Proposed Preschool & Primary School, at 1 Rosemead Road, in Hornsby, NSW

Traffic impact and parking assessment study

Addendum to the Traffic impact and parking assessment study report, dated February 2020

Re: Updated Acoustic Comment and Advice for the Proposed Development of a Blue Gum Community Preschool and Primary.

Figure 7.2: Car stopping sight distance

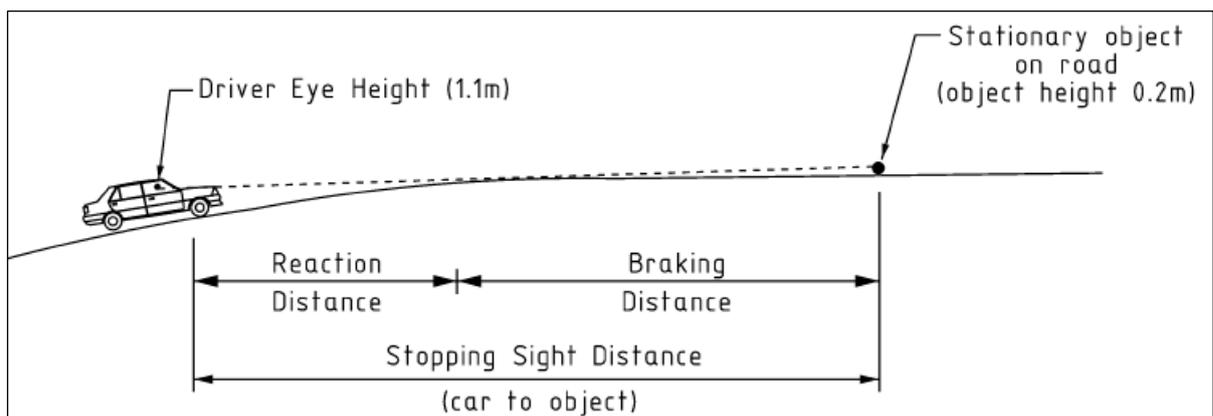
According to the Austroads Guide to Road Design, Part 3: Geometric Design, the Stopping Sight Distance (SSD) is “the distance to enable a normally alert driver, travelling at the design speed on wet pavement, to perceive, react and brake to a stop before reaching a hazard on the road ahead” and, for 50km/h speed limit zone, the very minimum required Stopping Sight Distance (SSD) is 42m (refer to Table 7.1).

In other words, introduction of, on average, at least 71 ingress vehicles' turning movements at the proposed location for the entry driveway [where, currently, the existing driveway is] would significantly increase the chance for severe crossing turning collisions to occur as result of the fact that even an alert approaching driver, travelling at the speed limit, may not have enough time or distance to perceive, react and brake to a stop before reaching a turning vehicle on the road ahead, at the entry to the subject site (refer to Figure 7.2).

In addition, this substandard sight distance significantly creates the chance for rear-end collision between a vehicle slowed down in order to turn left into the development site and a southbound through travelling vehicle on Rosemead Road.

In other words, with a left turning vehicle still on the road, the available Stopping Sight Distance would be even shorter than the measured 26m (refer to Photomontage 7.2).

Figure 3.1

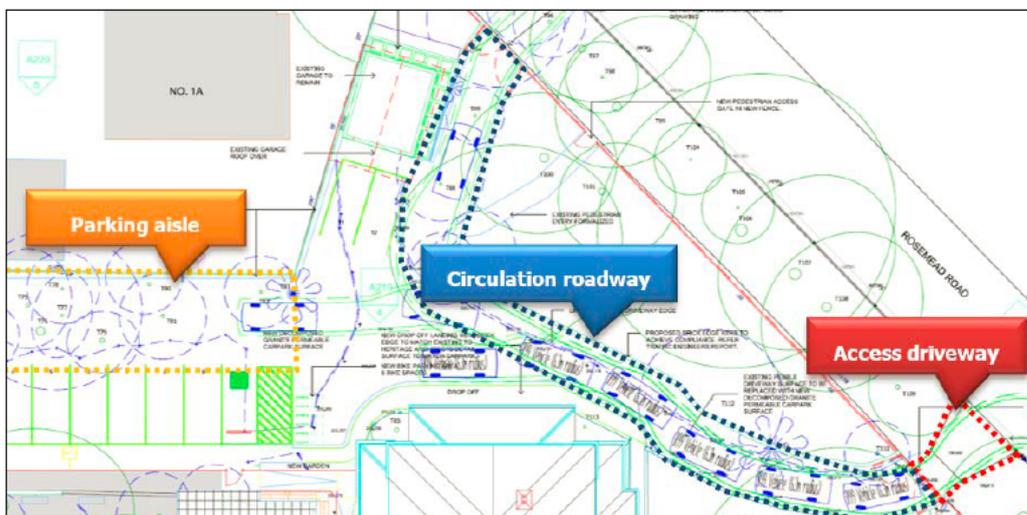
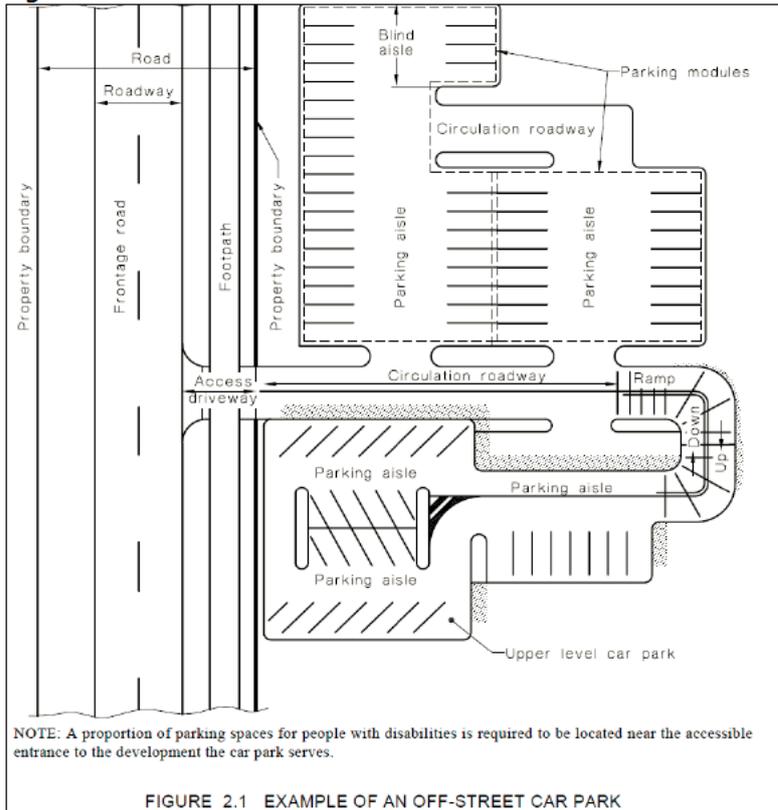
In my opinion, while six cars could be physically "accommodated" [to apply the exact expression used by 'Planning Ingenuity'] in the entry driveway, the driveway itself is not supposed to be blocked nor occupied by parked vehicles.

However, according to AS2890.1:2004, what is depicted on Figure 3.1, is not even an 'Access driveway', as it is wrongly called that way by 'Planning Ingenuity', but, rather, it is 'Circulation roadway'.

According to the Australian Standard AS 2890.1:2004, the following are definitions for the access driveway and circulation roadway, refer to Chapters 1.3.1 & 1.3.9, respectively (refer to Figures 3.1 & 3.2):

This simply means that the proposed solution is against the minimum standard requirements.

The Australian Standard AS2890.1:2004 does not permit vehicles to either be parked or intentionally stopped [even for a short period of time] on either access driveway or collector roadway.

Table 3.2
 (Source: Figure 3.2, AS2890.1:2004)

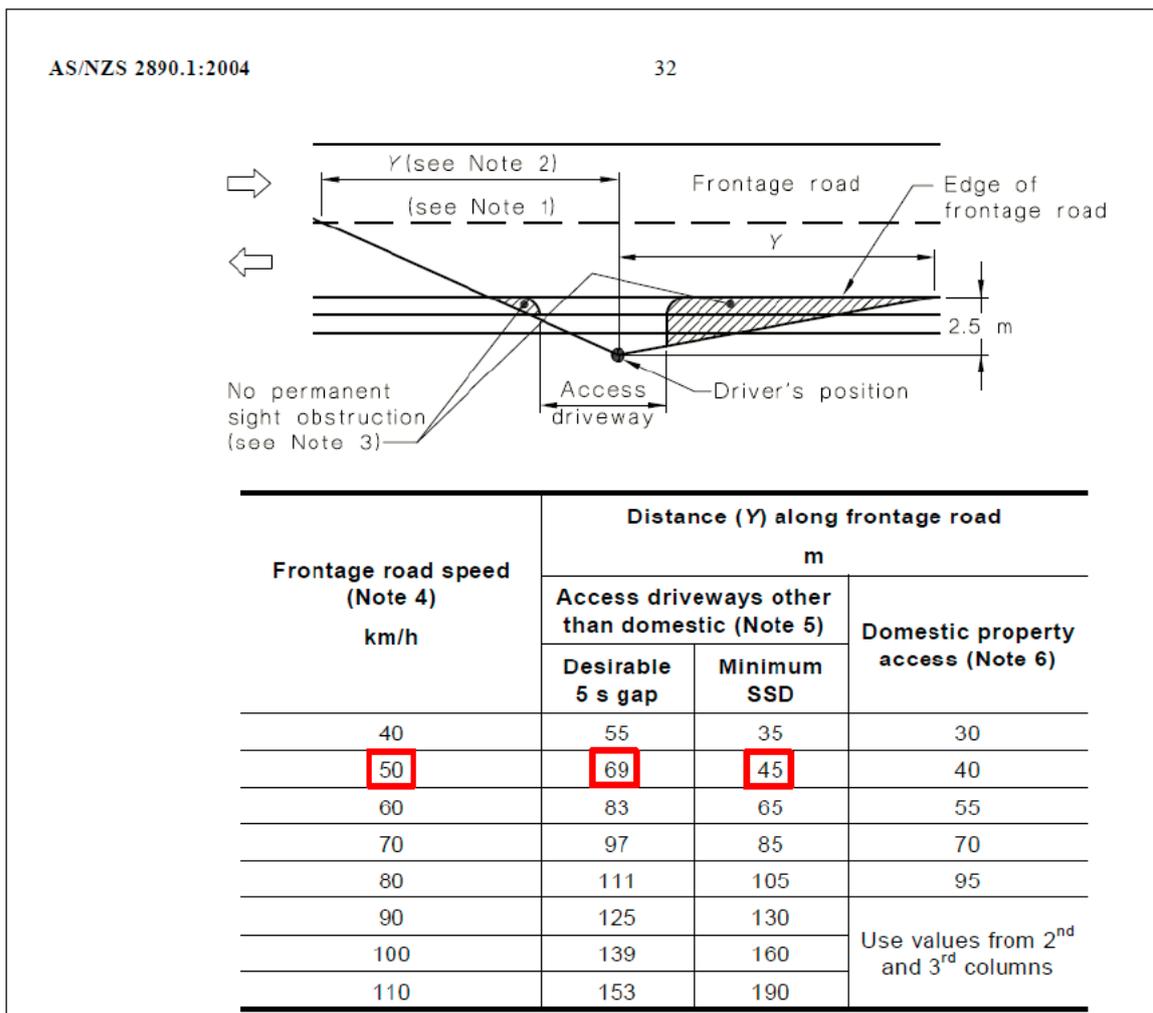
Instead, with the reference to Figure 3.2 of AS2890.1:2004 (refer to Figure 3.3), in a 50km/h speed limit zone, the minimum Stopping Sight Distance (SSD) is 45m, while the available SSD is only around 26m (refer to Photo 3.1).

In accordance with AS 2890.1, Figure 3.2, and with the frontage road being located within a sign posted speed limit zone of 50km/h, access driveways 'other than domestic property access' is required to provide a minimum Stopping Sight Distance (SSD) of 45 metres.

the available Stopping Sight Distance (SSD) was measured to be only around 26.0m (refer to Photo 3.1).

In addition, the Minimum Safe Gap Distance (MGSD) from an egress driver's point of view [corresponding to 'desirable 5seconds gap'] is no more than the same 26m, which is much shorter than the minimum required 69m (refer to Figure 3.2).

As a conclusion, the SSD and MGSD are not compliant with the standard requirements as per AS 2890.1:2004.
